Hydrology Supplementary Information

Project name Balliemeanoch Pumped Storage Hydro	Client ILI Pump Storage Hydro PLC	Subject CAR Application Request for Further Information	Date 06 March 2026
Prepared by [REDACTED]	Checked by [REDACTED]	Verified by [REDACTED]	Approved by [REDACTED]

Figure 1: Stage duration curves: Baseline and with Development

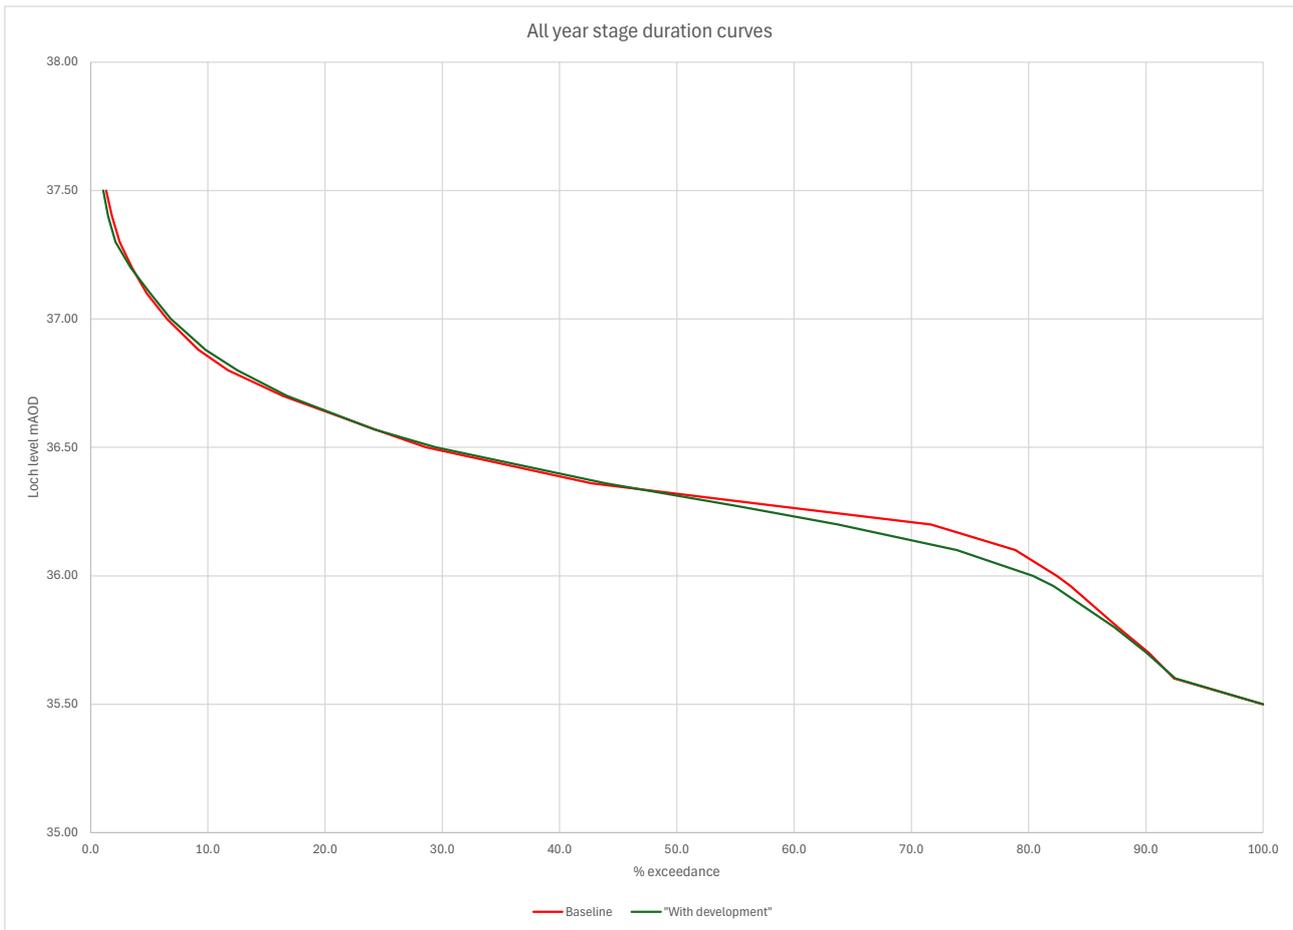
1.8	All input data used for modelling should be submitted along with model outputs and the model itself where practicable.	Refer to Appendix E		
1.9	Currently submitted modelling appears to only cover 11 years 2014 to 2025. A timeseries of at least 30 years should be modelled to determine the natural and current flow/level statistics. Please re-run and submit updated modelling to cover a minimum 30-year period.	Modelling has been completed with an extended 30-year timeseries. Refer to section 3.1 for more information.

The impact of the Development on loch levels based on the 30 year analysis period is shown in the stage duration curve in Figure 1. Note that the baseline stage duration curve is based on modelled rather than observed levels in order that it can be directly compared with the “With Development” modelled scenario.

This shows the percentage of time that the loch is at different levels. Because of the high and low “hands off” thresholds, the highest and lowest loch levels experienced are unchanged. For higher levels greater than the 50th percentile (i.e. exceeded 50% of the time) and less than the 90th percentile, there is minimal impact on levels. Generally, the impact appears to be less based on the 30 year analysis period, compared to the previous 10 year analysis period. The mean or average loch level (i.e. exceeded 50% of the time) is very slightly reduced from 36.32mAOD to 36.31mAOD (previously 36.36 to 36.33 mAOD for the 10 year analysis period). Maximum differences lie around the 70th percentile with a reduction of 70mm from 36.21mAOD to 36.14mAOD.
